ADDENDUM NO. 1

Project: **PARKS-2026-01 – DSRP 2026 IMPROVEMENTS PROJECT**

Owner: **City of Dripping Springs, Texas**

Date: **May 26th, 2026**

2 ADD ALT 2A - REINFORCED CONCRETE PAVEMENT DETAIL

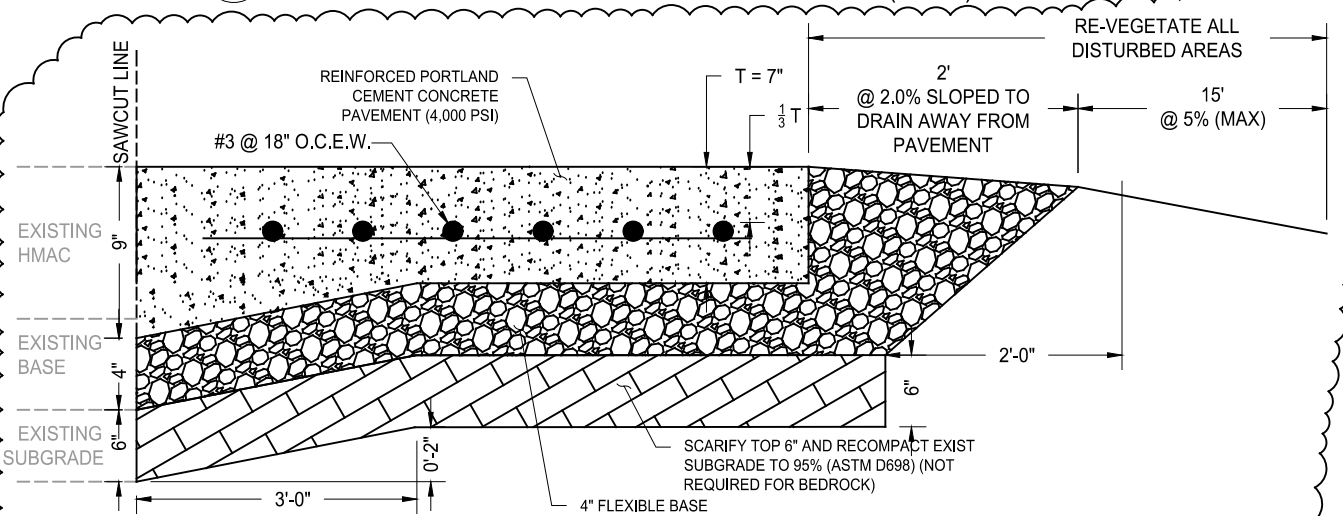
5. *Question:* If all alternates are accepted. Would it be acceptable to provide concrete pavement at the dumpster pad area. If so could you please provide a quick description of thickness and steel reinforcement requirements. We feel that this could possibly be a cost benefit if all concrete areas can be poured together.

1. **COVER SHEET (Plan Sheet 01 of 28)** – *Added description for Add Alternate #2A.*
2. **SCHEDULE OF QUANTITIES (Plan Sheet 03 of 28)** – *Revised schedule of quantities to include Add Alternate #2A – Reinforced Concrete Dumpster Landing.*
3. **ADD ALT 2 TYPICAL SECTIONS (Plan Sheet 20 of 28)** – *Added details for Add Alternate #2A – Reinforced Concrete Pavement Section & joints.*
4. **SITE DETAILS (1 OF 3) (Plan Sheet 23 of 28)** – *Revised Detail 4 – Sidewalk Box Culvert dimension to clarify the width of proposed sidewalk = 4'0".*

Response: Add Alternate #2 – Reinforced Concrete Pavement is an acceptable alternative for the Hot Mix Asphalt Pavement section. Minimum requirements for Reinforced Concrete Pavement:

- *7" Portland Cement Concrete Pavement (4,000 psi min 28-day strength) with #3 reinforcing bars installed mid-slab at 18" O.C.E.W.*
 - *Where new pavement ties to existing asphalt pavement, Concrete pavement thickness shall transition to 9" over a 3-ft taper length*
- *4" compacted crushed limestone flexible base (100% max density at moisture content within +/- 2% optimum (TEX-113-E)*
- *Scarify & Recompact existing subgrade to 95% (ASTM D698) (Not required for bedrock)*
